### **RE04 LAYOUT PACKAGE**

Figure 1A WALL RE-04 DETAILS

ACF West, Inc: SR 520 - Medina to SR 405

# REINFORCED SLOPE DETAIL SECTION RE-A AND RE-B (NOT TO SCALE)

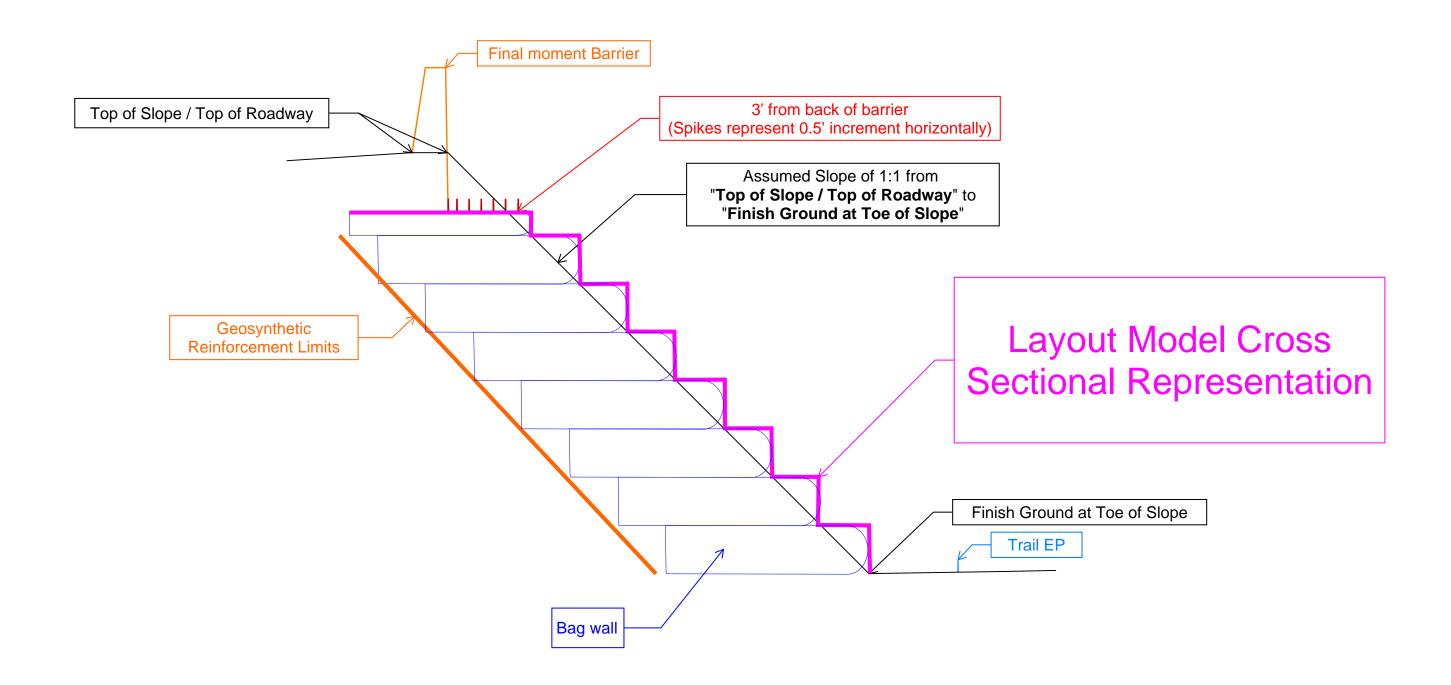
ACCEPTED AS NOTED
